10-BSTD-01

Re: October 13, 2011 Nonresidential Staff Workshop - 2013 Building Energy Efficiency Standards (AHRI Comments on Measures Related to Unitary Air Conditioners and Heat Pumps)

FAN CONTROL AND INTEGRATED ECONOMIZER PROPOSAL COMMENTS

Re: AHRI Comments on December 9, 2010 Single Zone VAV Presentation at the Nonresidential HVAC Stakeholder Meeting #2 and April 21, 2011 CASE Report on Fan Control and Integrated Economizers (Docket Number 10-BSTD-01; April 27, 2011 Staff Workshop – 2013 Building Energy Efficiency Standards”)

Figure 2 – AC Unit Control – M5 AC-2.2C

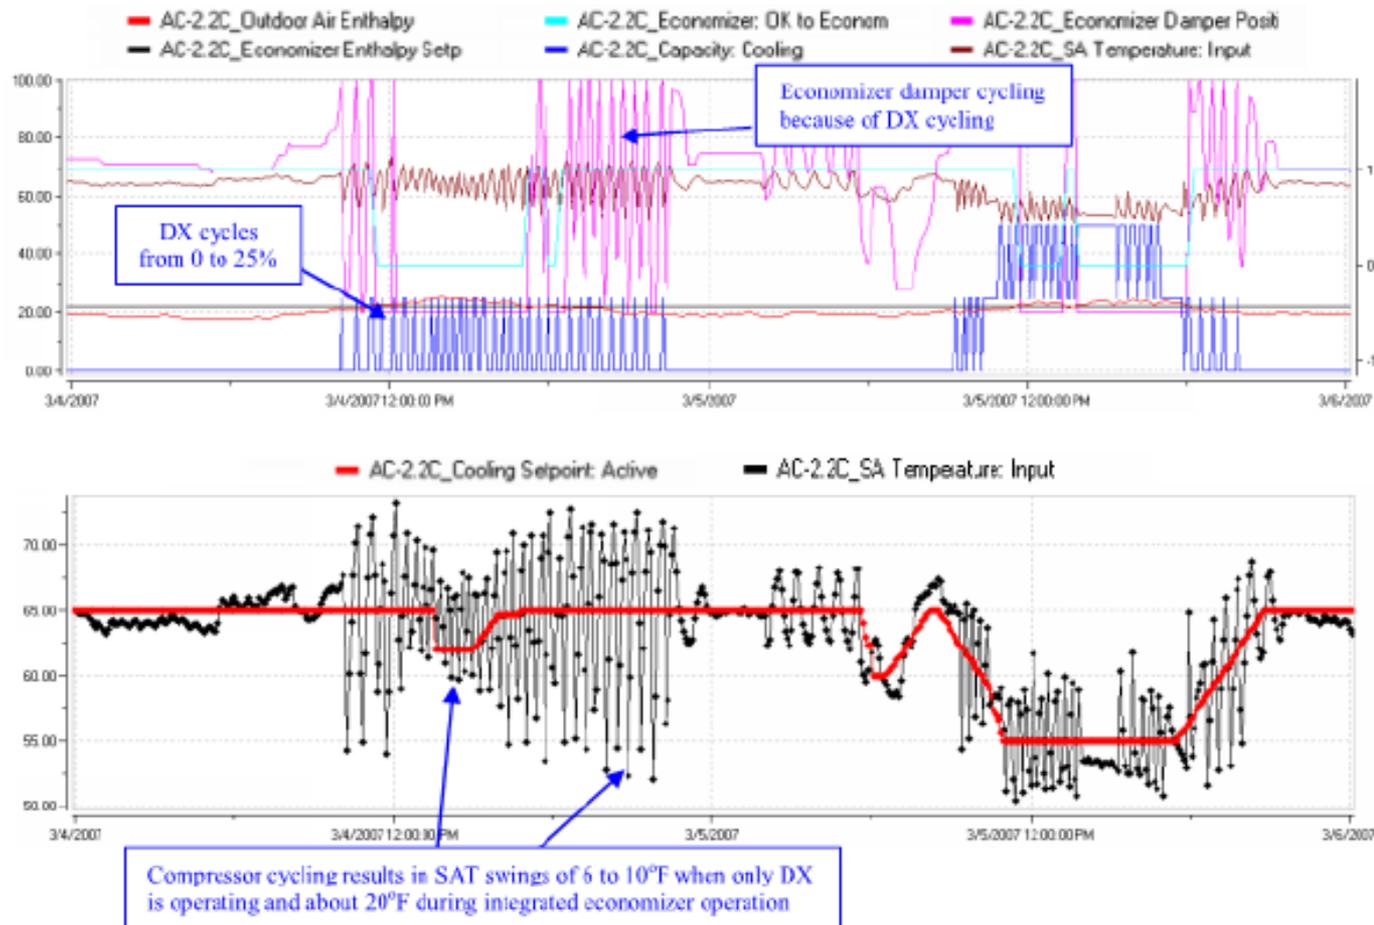
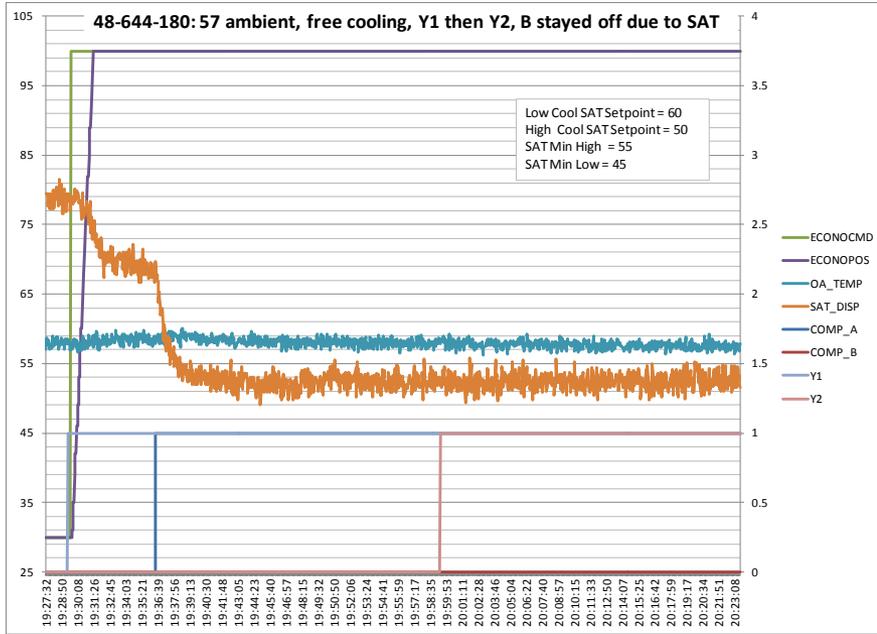
- In the CMP justification for the integrated economizer proposal a plot of cycling problems with an economizer was documented and this is driving the proposal for capacity modulation down to 20% actual capacity

- The unit in question was a VAV unit and already had capacity control down to 25% and moving this to 20% will not eliminate the issue.
- I believe the problem is that the economizer and capacity control are controlling to the same temperature sensor, but appear not to be link in software which results in one overriding the other and causing the cycling

- What would solve the problem is linking the economizer and compressor control such that the dampers are locked open during integrated compressor operation. There are many products on the market today that do not have the problem as mentioned.

This is a temperature trace from a VAV units that had a minimum capacity step of 25% where the dampers and compressor were fighting each other

Compressor Efficiency

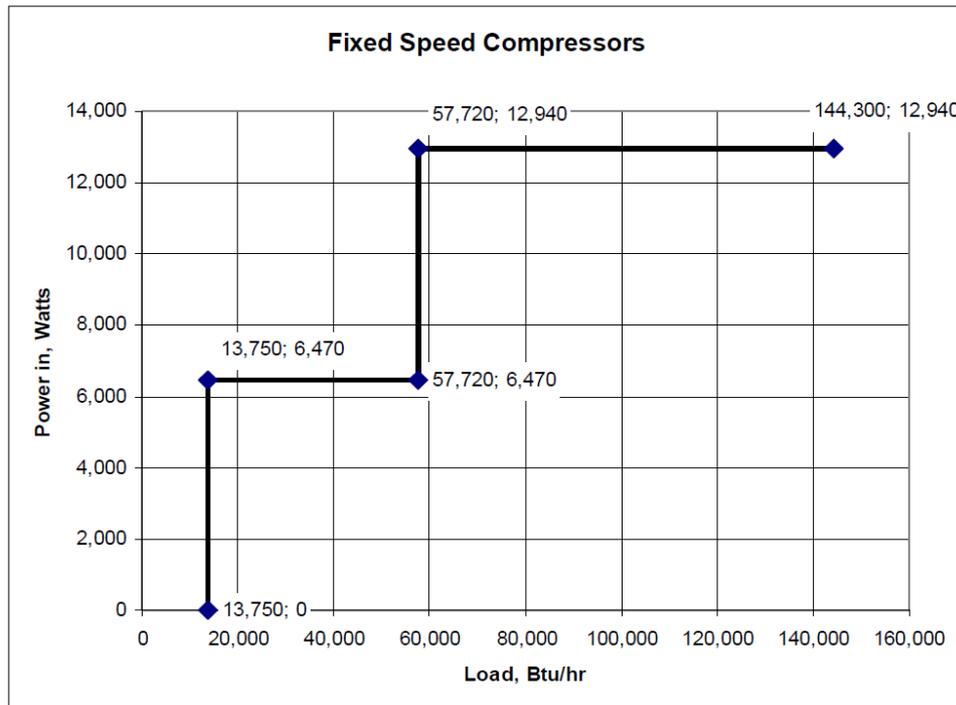
- In one of the reference papers a plot was shown that indicated variable speed compressors are significantly better at reduced load. **This curve is totally wrong.**

This curve is saying that at part loads the compressor power is constant which is wrong. A single compressor will cycle and the power will be the integrated sum of the on-off power plus a degradation for startup

The degradation coefficients are well defined and are test derived for residential systems or there is a conservative defaults can be used and is defined in AHRI 210/240 and AHRI 340/360 and is used in SEER and IEER ratings.

Real Compressor Efficiency Curve

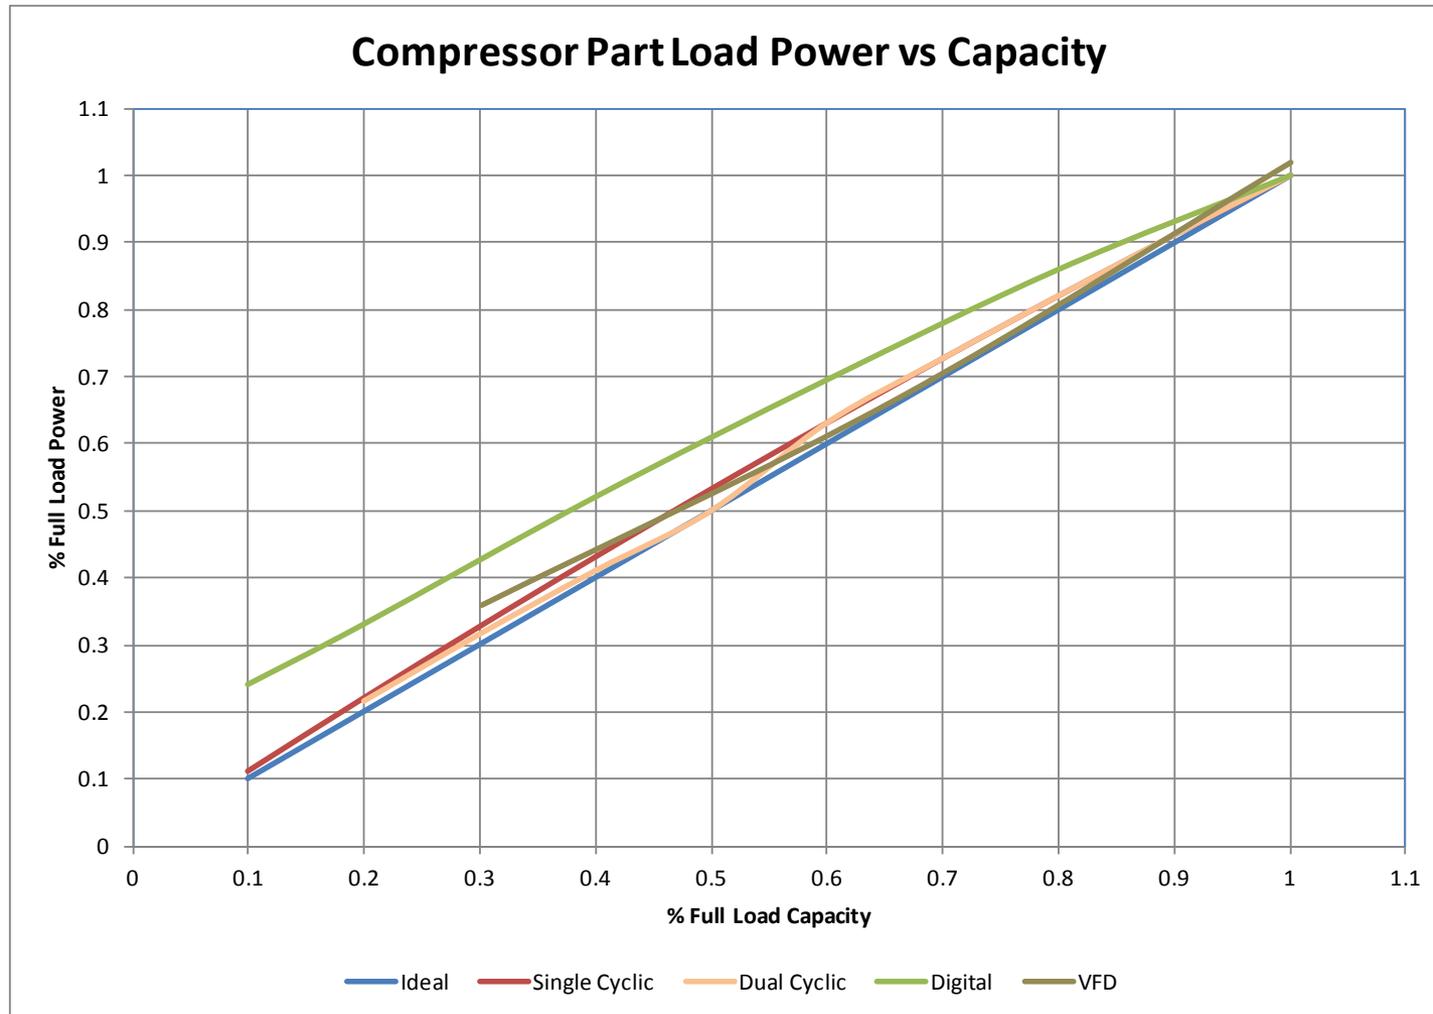
This is a plot of the % full load compressor power vs the full load % capacity at a constant saturated suction and saturated discharge

Alternate Compressor Plot

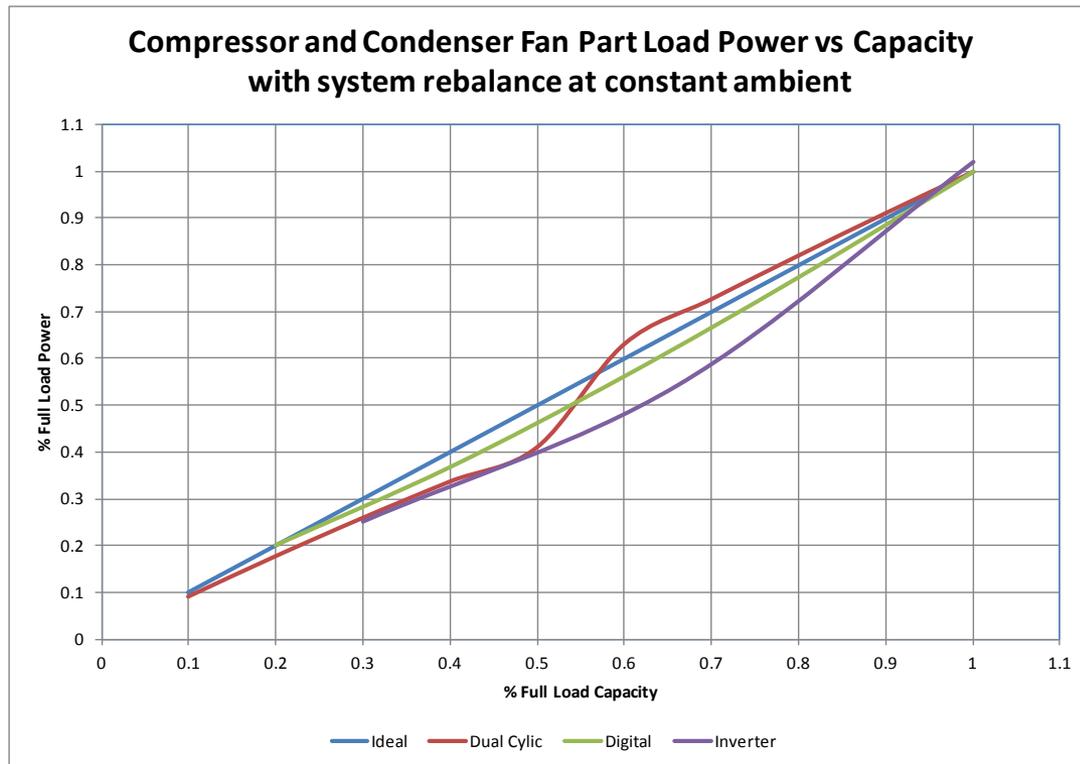
- The prior plot is misleading as it is only a compressor plot and does not factor in the rebalance of the heat exchangers as they unload in a real system.
- I created a plot of various compressor options to show what a real system impact would be.
- This is a plot of compressor and condenser fan power at a fixed ambient and return air condition

The huge performance improvement is not there and dual compressors on a single circuit can very close with a much lower complexity and cost than variable speed and better in performance than Digital

This is actual confirmed in that most who use the digital have to limit the capacity unloading to get a good SEER

Also note that the variable speed can only get done to 30% and the requirements is 20% which is more like 15% displacement

Figure 5. Combined Measures: Fan Control and Integrated Economizer – Single Zone DX:
% design fan speed versus % design cooling load for a representative zone

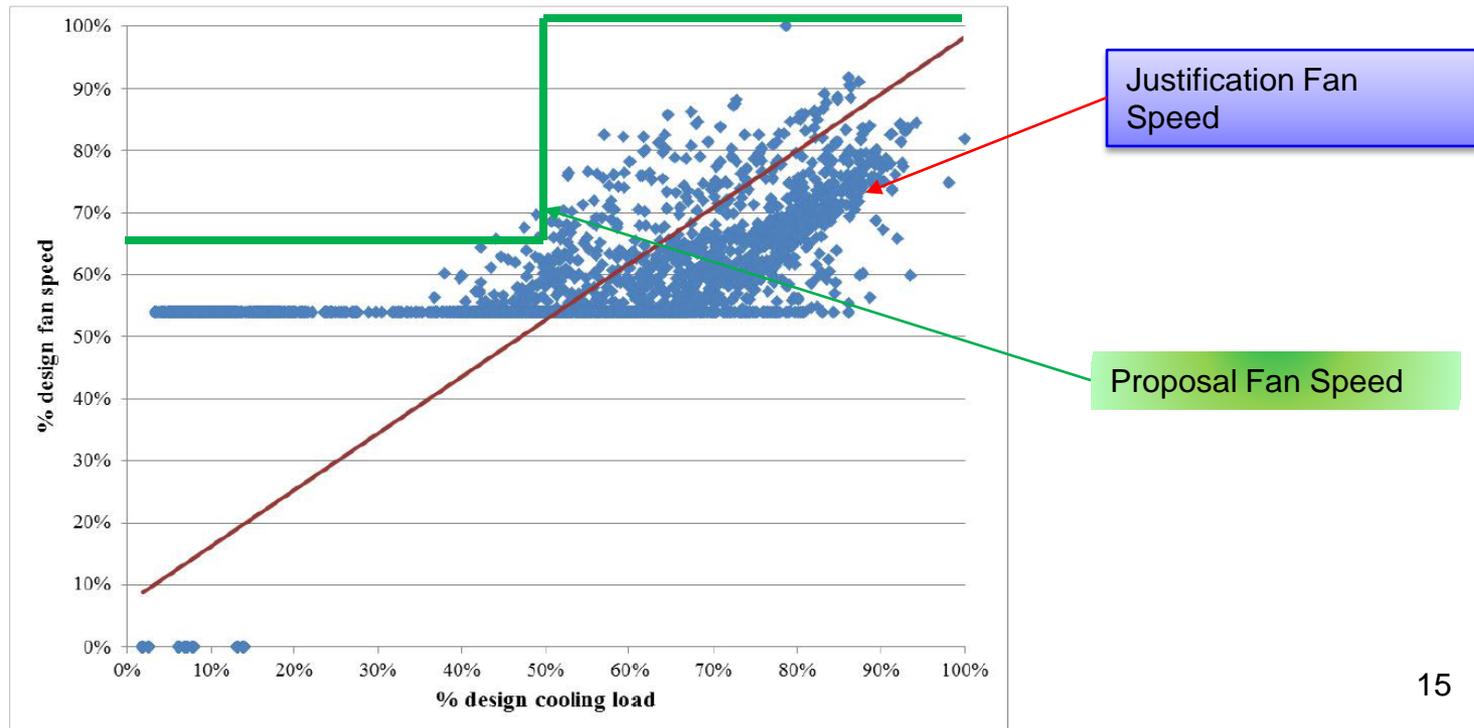
- The proposal requires for DX products a fan speed of 66% below a load of 50%
- The justification document assumed Variable speed fans starting at 100% load down to a speed of 50% at 50% load
- **Savings are overstated!**

Humidity Control

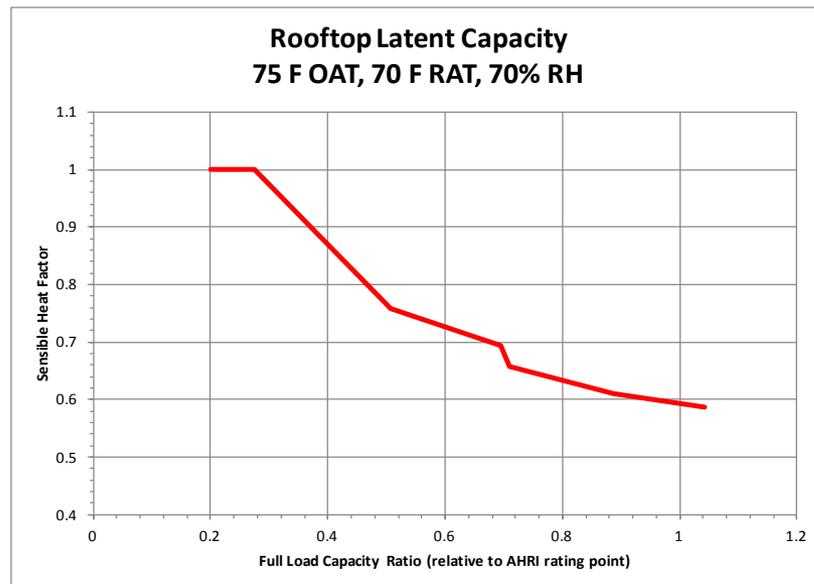
- Study claims that better humidity control will be obtained with the variable capacity and variable speed fans.
- Variable speed fans will help part load humidity control during non-integrated low load operation, but during economizer operation the fan is at high speed to get full benefit of the economizer
- The variable capacity compressor will actual decrease humidity control as shown in the plot of operation at economizer integrated conditions

Due to the rebalance of the heat exchangers the saturated suction rises and the latent capability of the DX coils at a constant CFM decreases and below about 30% capacity the coils is only providing sensible cooling

Chart A

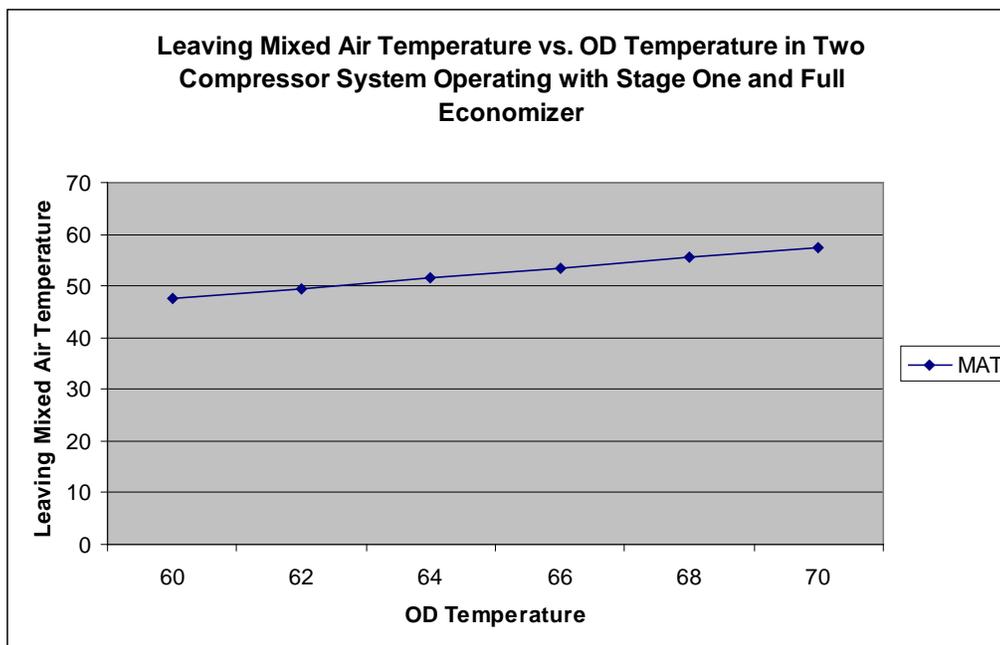
Chart A shows what the supply temperature would typically be if one stage of mechanical cooling is running in a two stage compressor unit, and the economizer is fully open at different outdoor temperatures with 50-60% relative humidity in the air.

Chart A suggests that the supply temperature could get below 50 °F when the outside air temperature is 60 °F. But there should be very few instances in typical applications, especially in the dry climate of California, when mechanical cooling is needed at an outside air temperature of 60 °F. We believe that most typical applications will not need mechanical cooling until the outside air gets closer to 65 °F. In this case, the economizer dampers do not need to close very often in order to maintain the supply air temperature above 55 °F.

Chart B

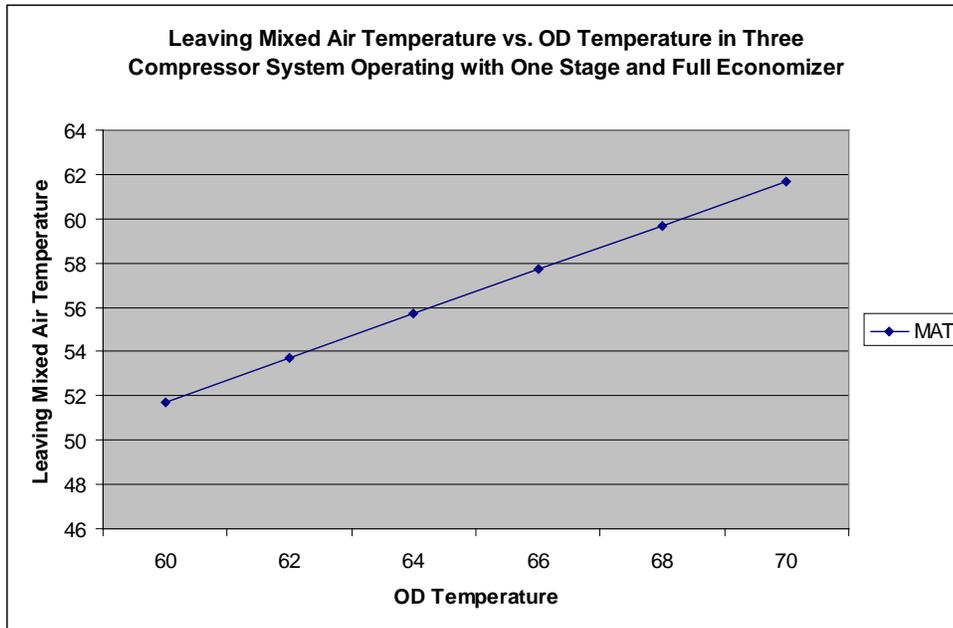
Chart B shows the supply temperature versus outdoor temperature for three-compressor units. The supply temperature for a three-compressor system only gets down to about 52 °F at an outdoor air temperature of 60 °F. There should be very few instances where the economizer dampers would close, even if the setpoint for closing the economizer dampers is 55 °F.

Chart C

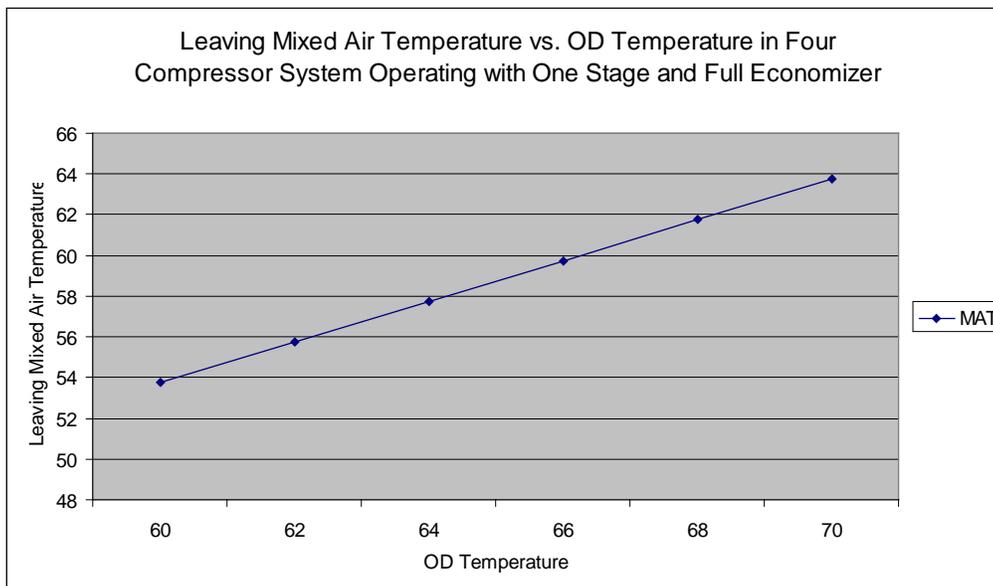
Chart C shows the supply temperature versus outdoor temperature for four-compressor units with face-split evaporator coils. At an outdoor air temperature of 60 °F, the supply is close to 54 °F. Therefore, the economizer dampers should seldom close when the outside air is 60 °F and suitable and the mechanical cooling comes on.
